Response
to
EPA's Proposed Plan
for the
Cabot / Koppers Superfund Site

Joint City and County Commission Meeting
8/30/2010

Robert Pearce

Off-Site Soil Sampling Results

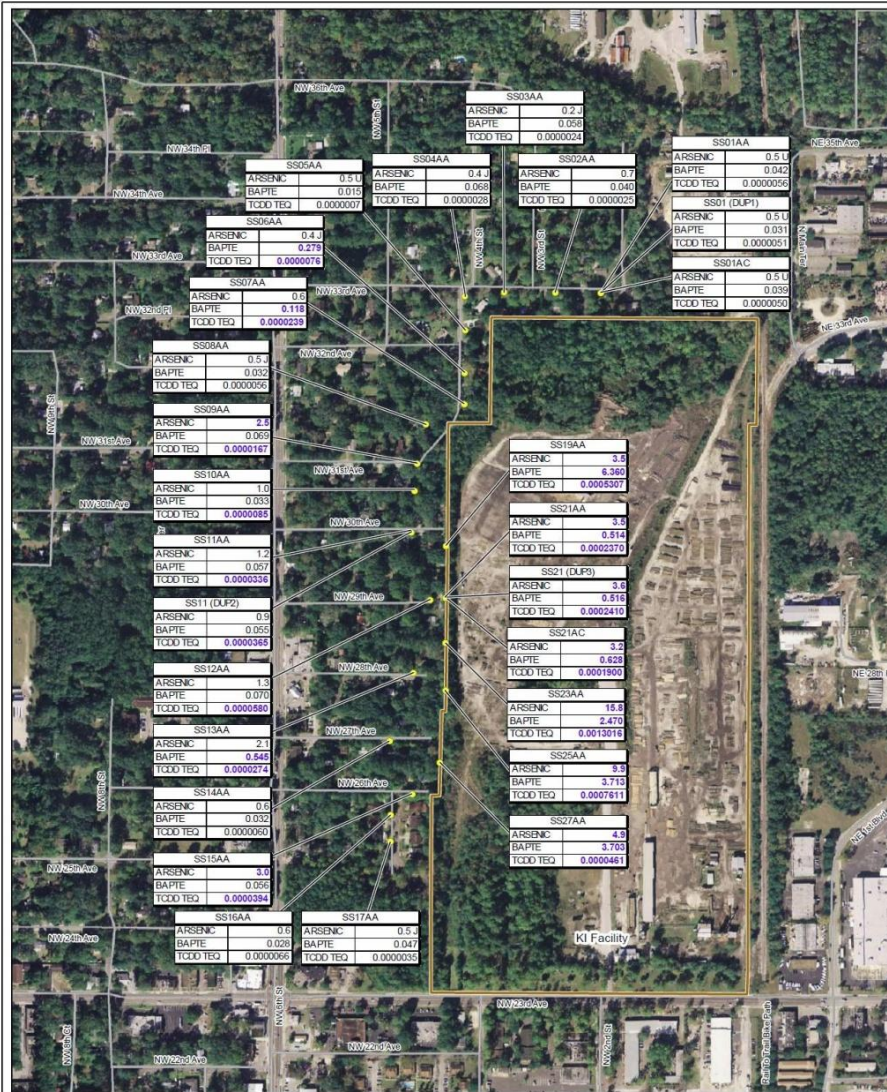
Issue #3

Off-Site Surface Soils

Sediment Reconnaissance Locations

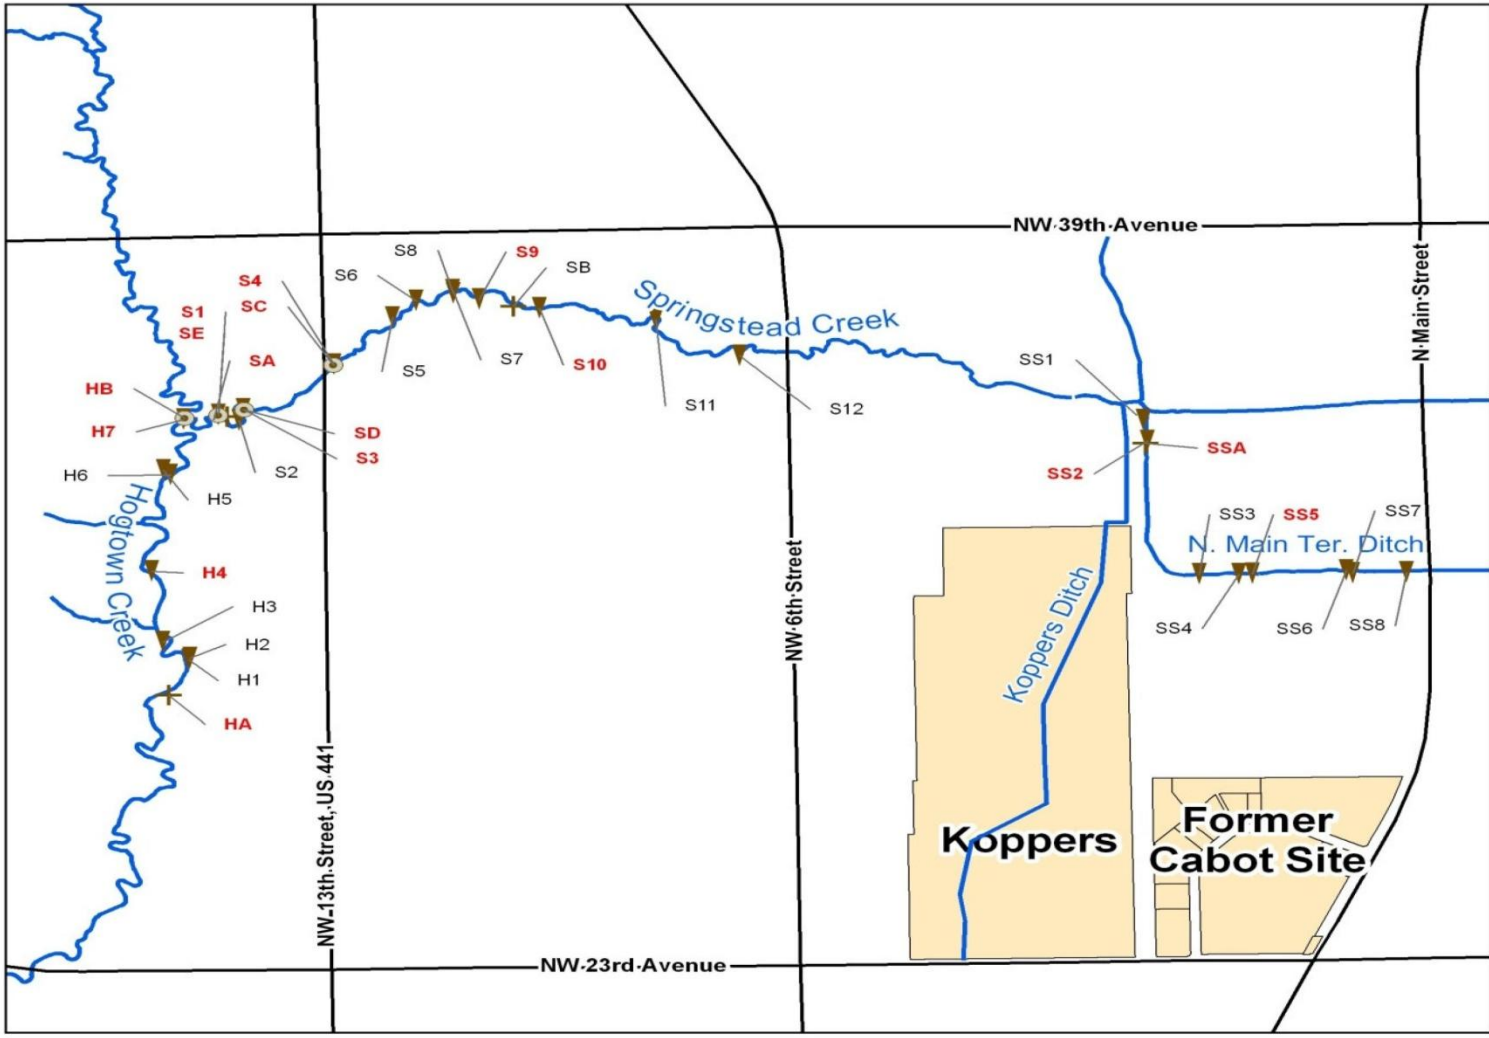
Issue #4 Contaminated Creek Sediments

Off-Site Soil Sample Results

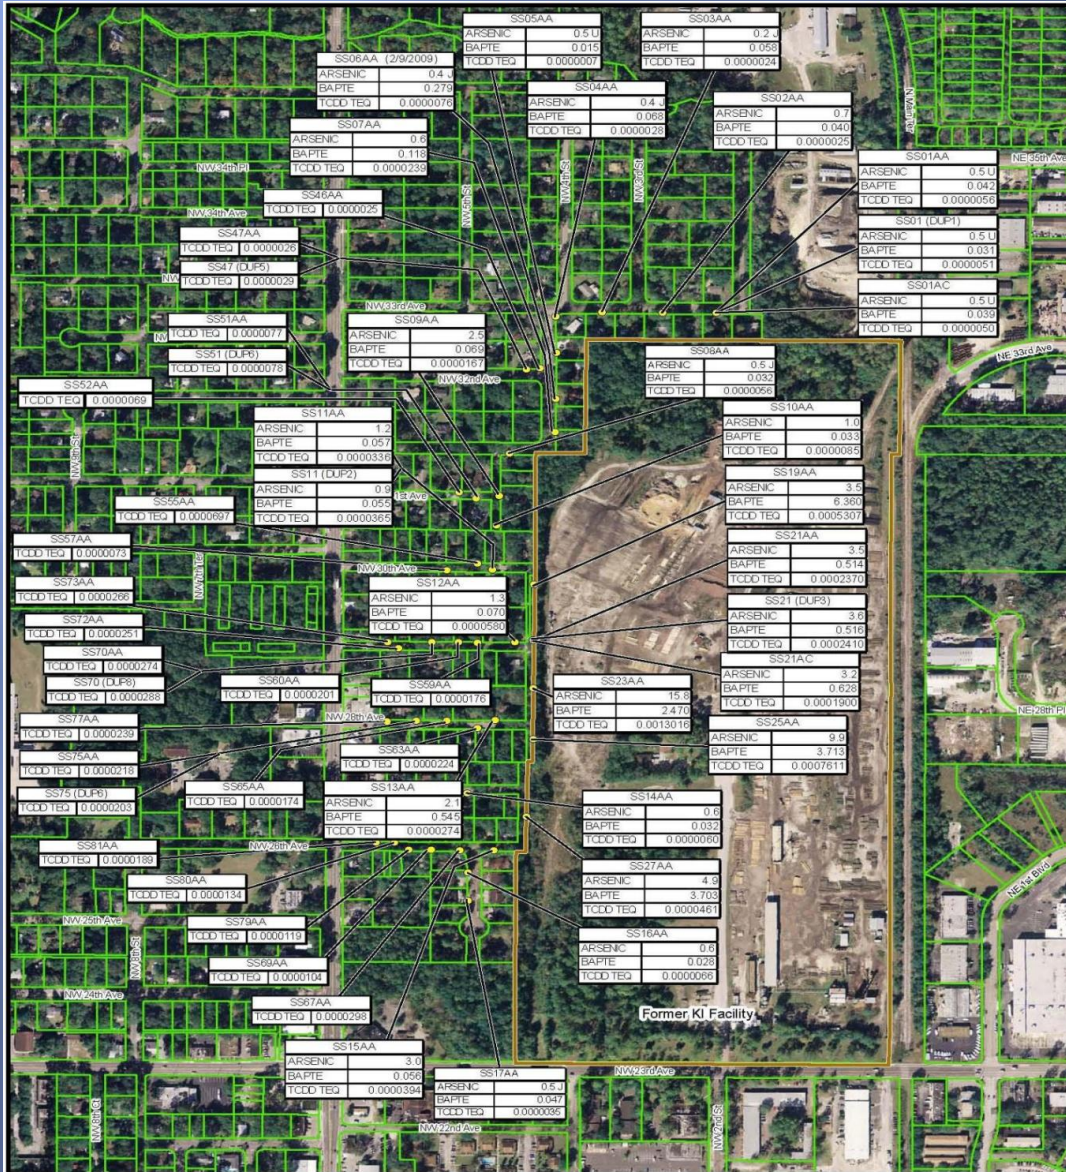
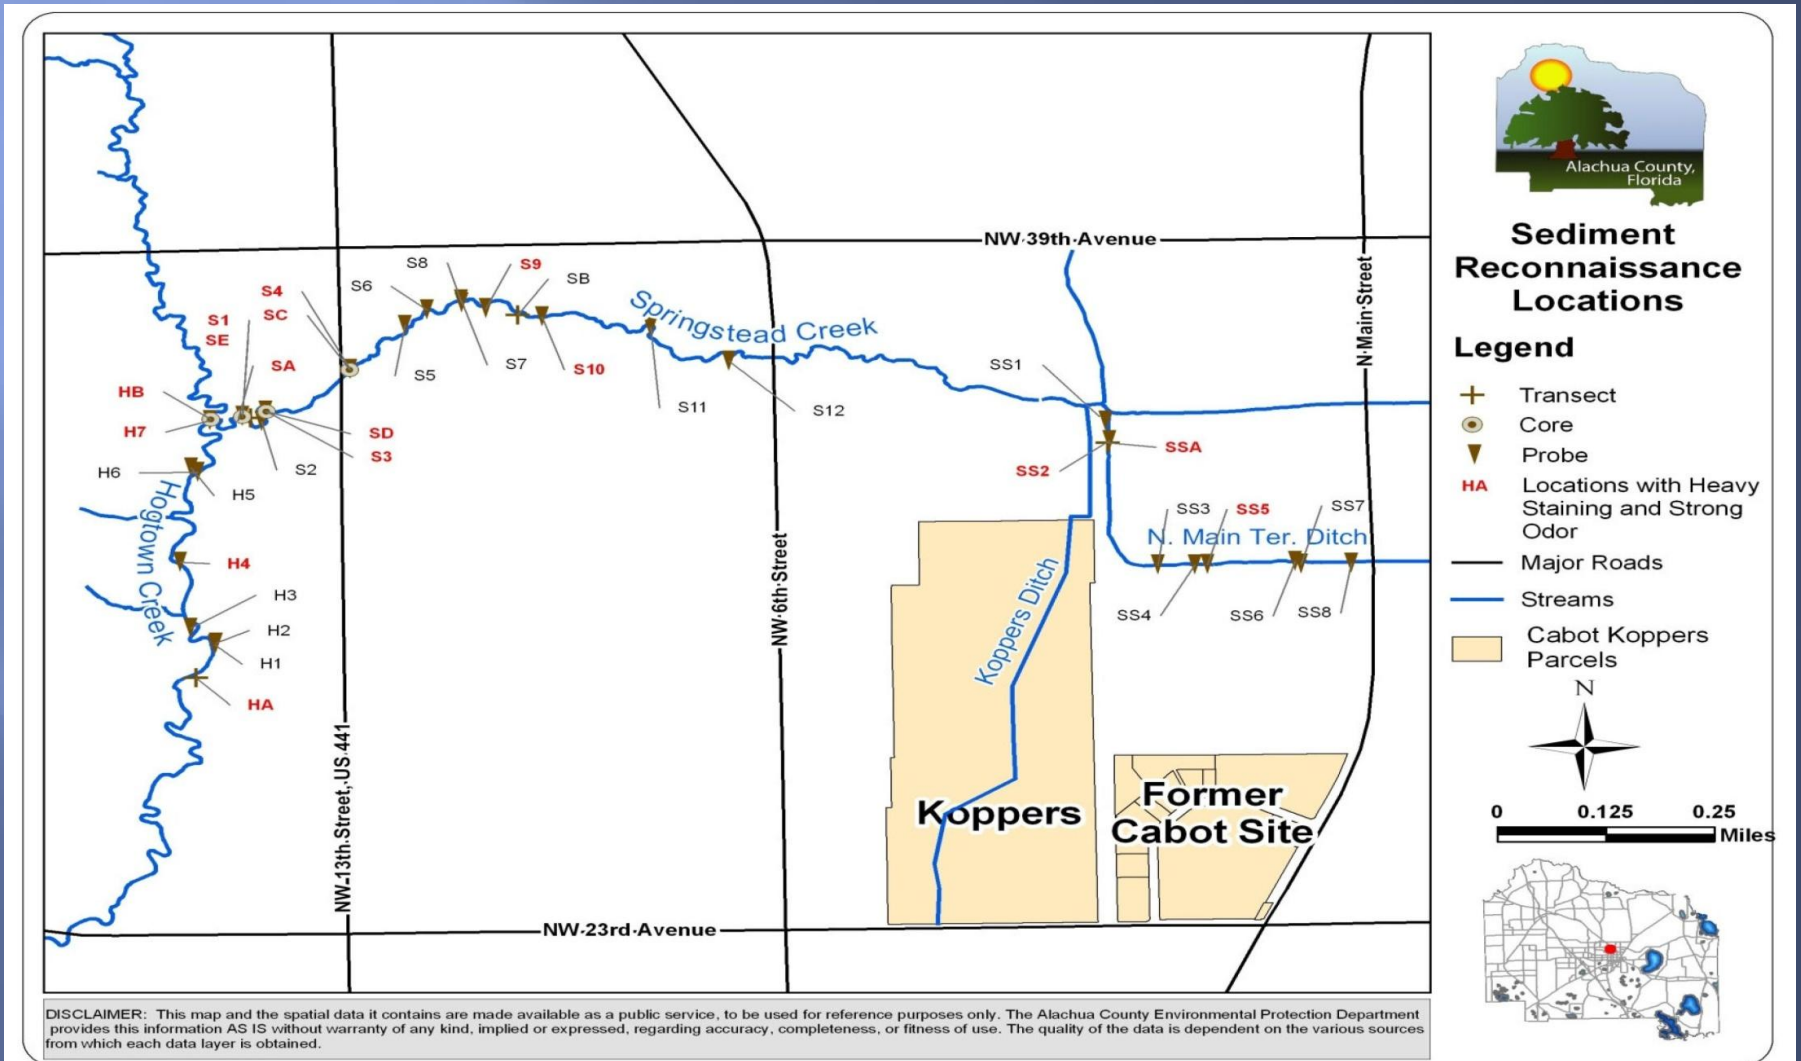
Off-site Soils Remedy

Beazer's “Interim” Stormwater Permit Application

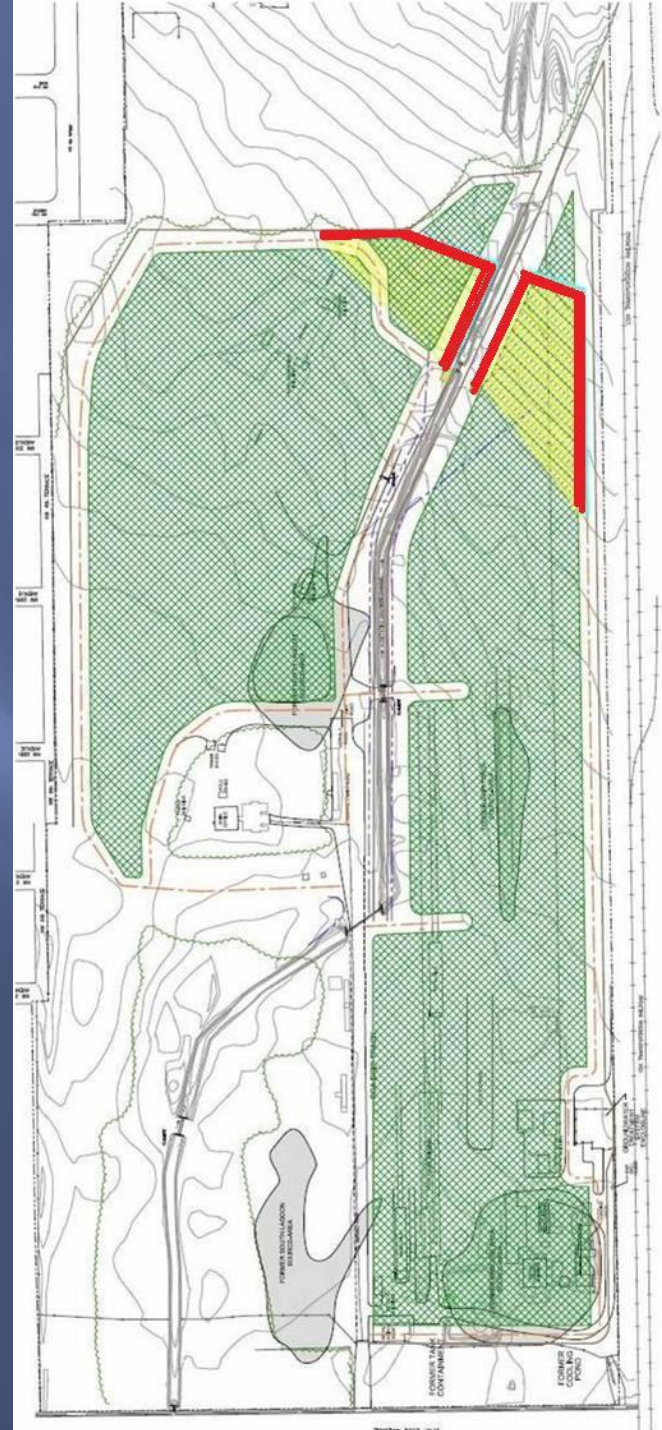
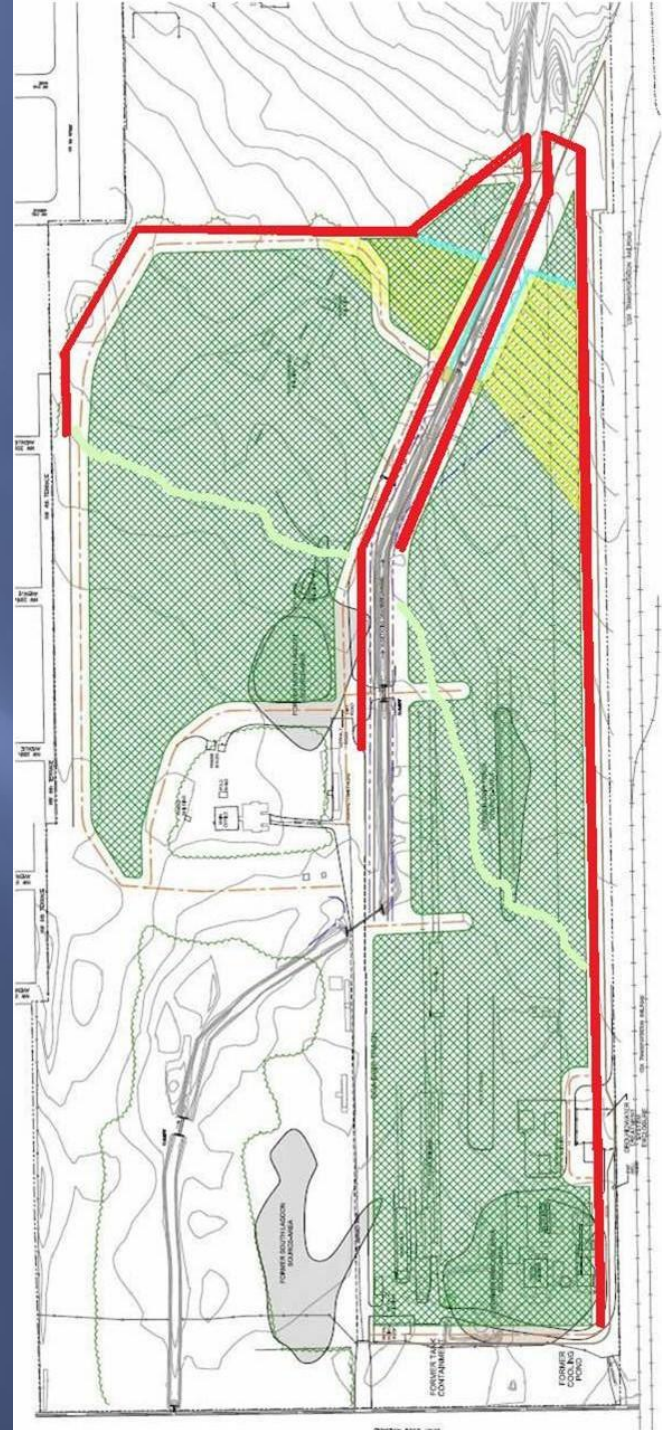
Creek Sediments/Stormwater Management Remedy

Enhanced “Interim” Stormwater Management Plan
